PRINTWORKS

STUDENT ACCOMMODATION SCHEME

PRINT-1000-ZZ-ZZ-RP-0002

NMA 2: DESIGN AND ACCESS STATEMENT ADDENDUM

FIGURE 30. Proposed Scheme - Printworks L03

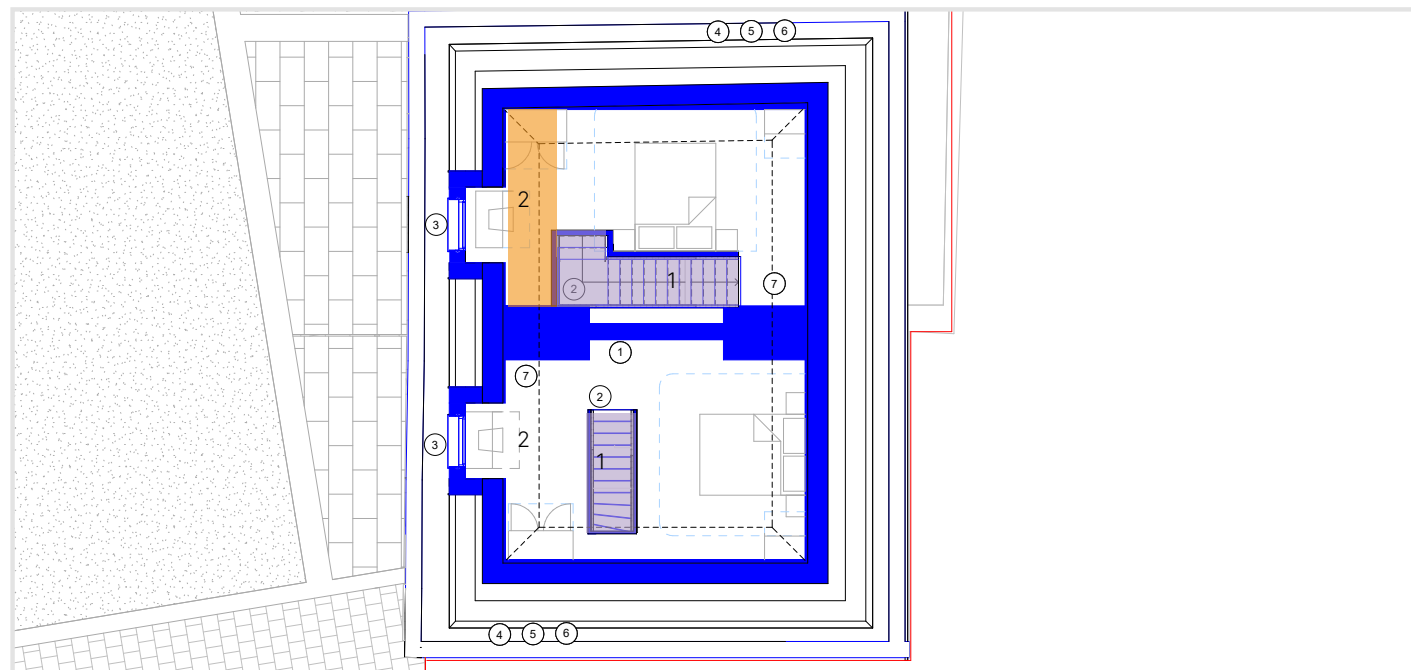
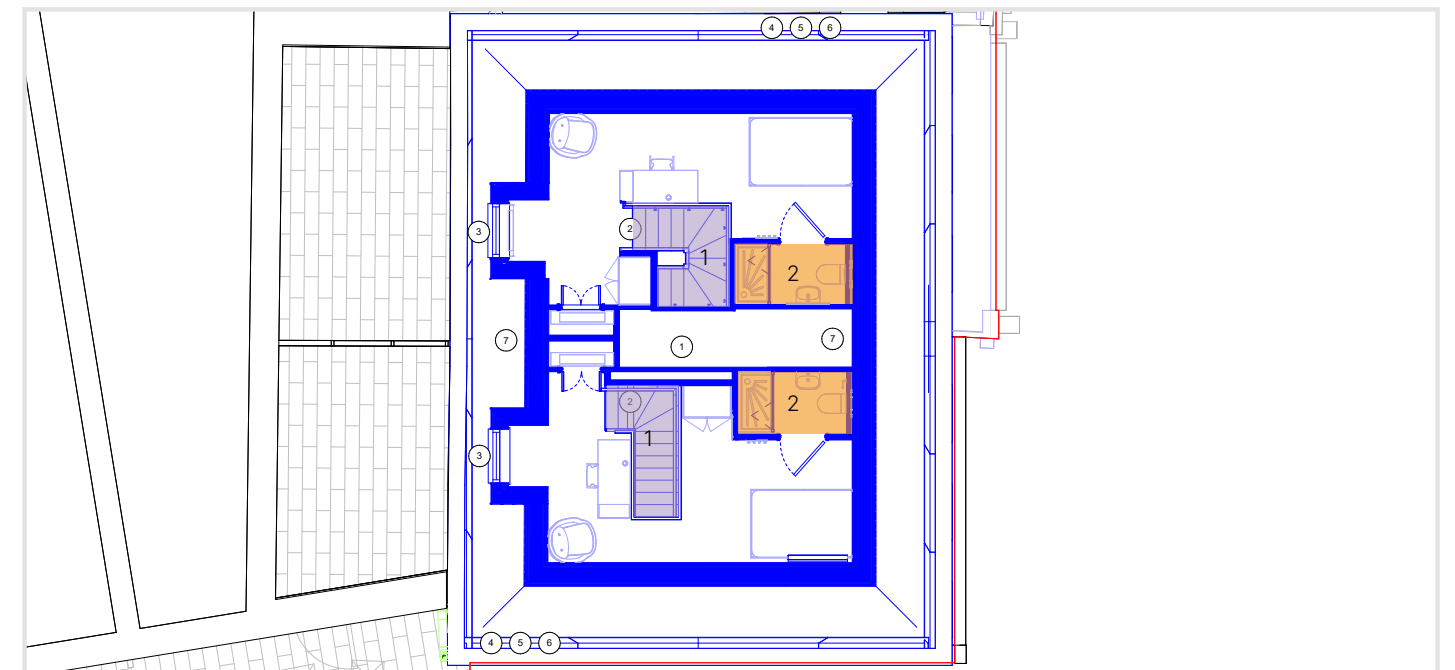
1. Staircase arrangement altered.
2. Ensuited to L03 rooms relocated.

FIGURE 37. Consented Scheme- Section through East Courtyard

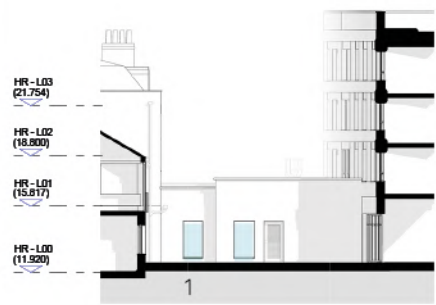
1. Amendments to structural columns in High Road Class E following Structural engineer input. Additional window added following structural coordination.
 2. Minor amendments to windows/external doors in response to MEP design development.
- Roof construction details and MEP Plant developed with specialist input. No overall changes to height. In accordance with submitted and approved energy and overheating strategy.
 - Louvres size and location developed with MEP consultant.

FIGURE 44. Proposed Scheme - 819 821 High Road, West elevation

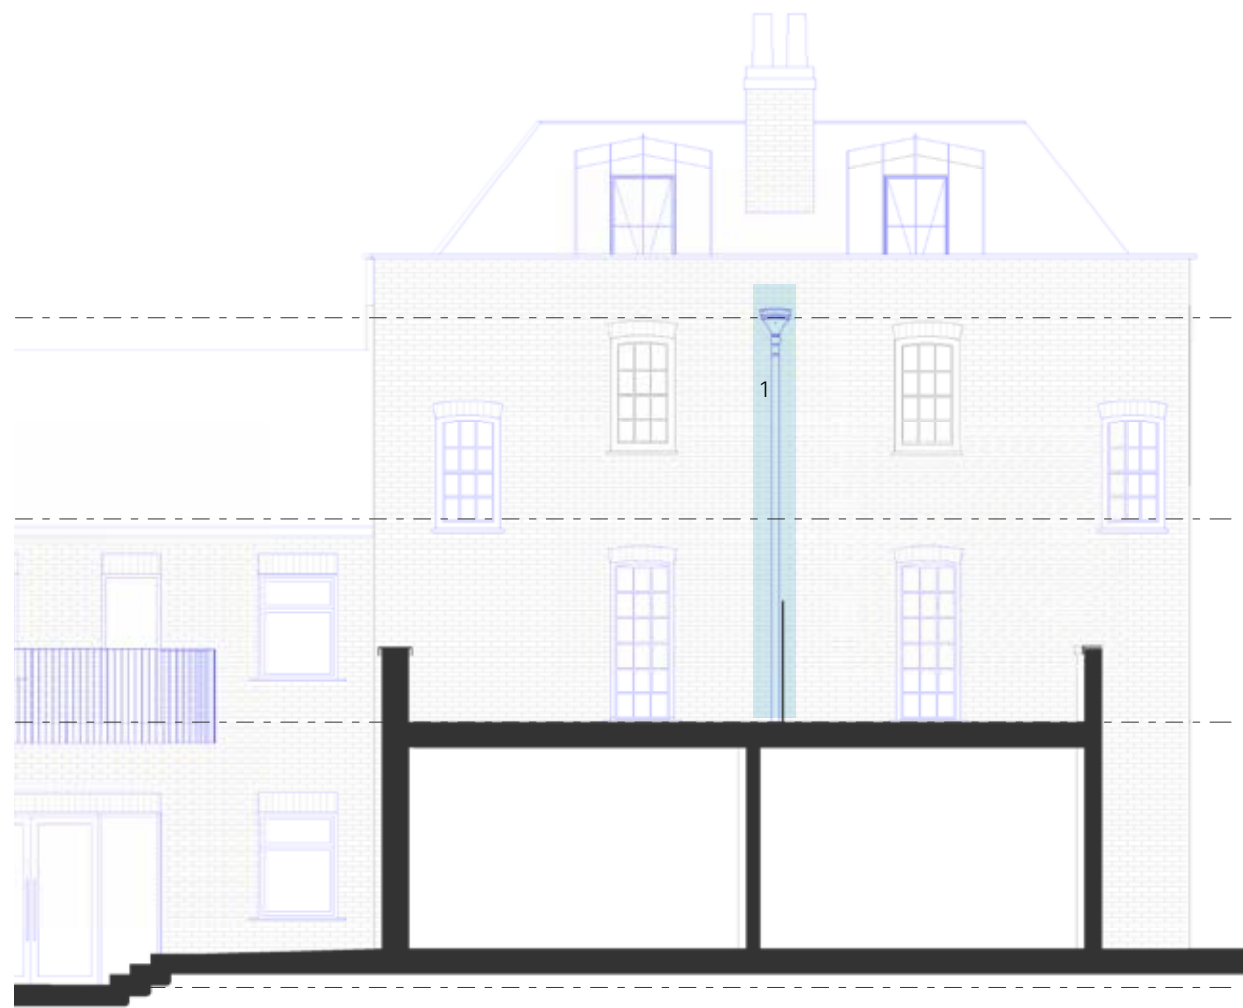
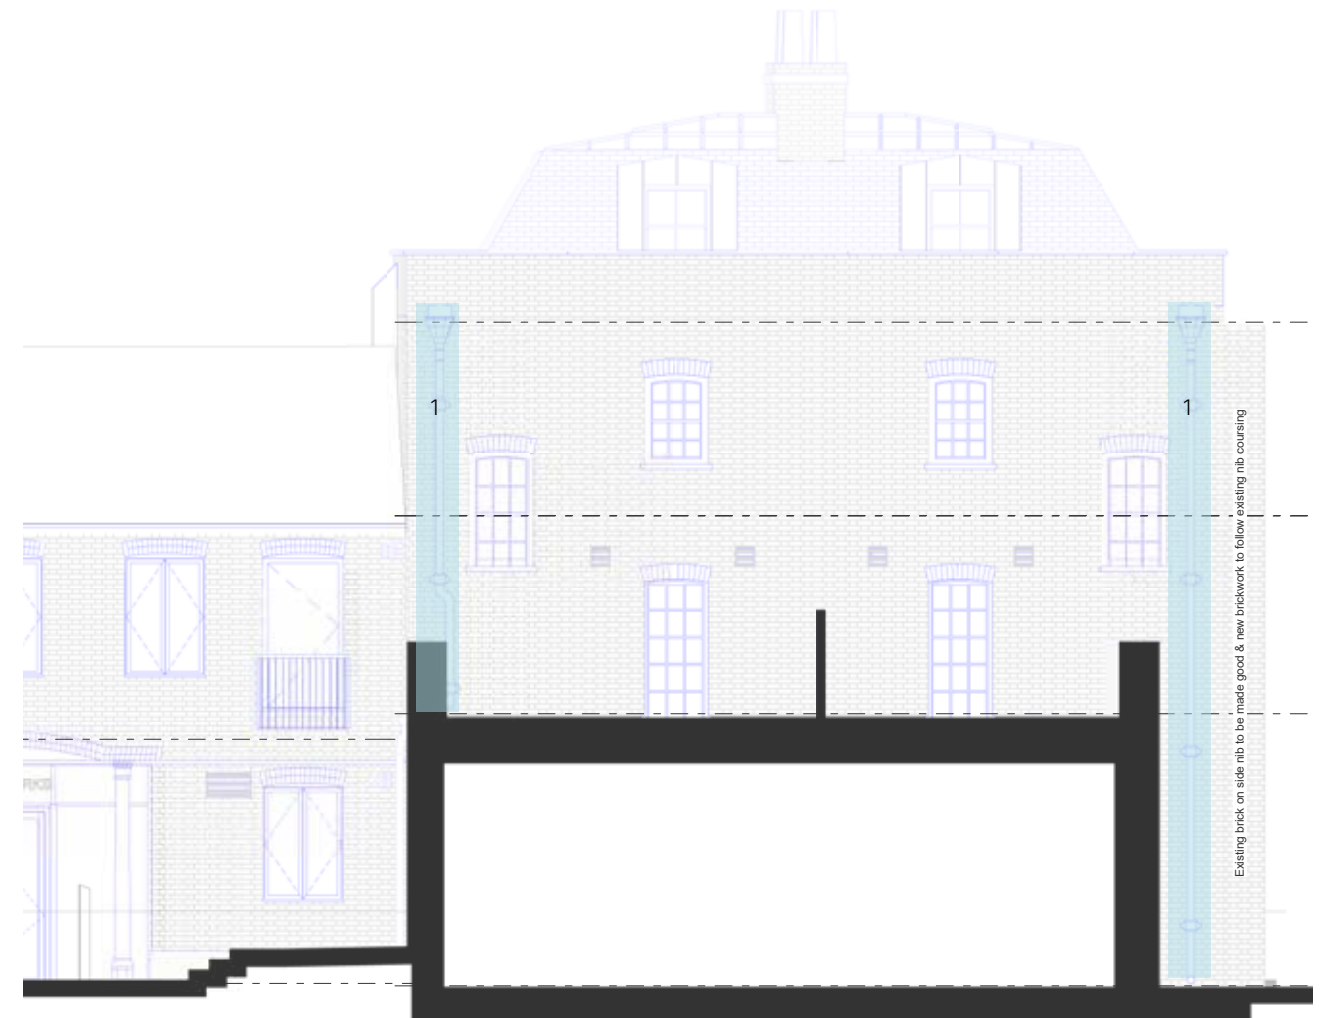
1. Rainwater pipes location reviewed to suit roof design development.
- Note the 819 821 mansard roof has been regularised via LBC Condition 8(b)xii.
 - Louvres shown indicatively, to be developed with MEP Engineer.
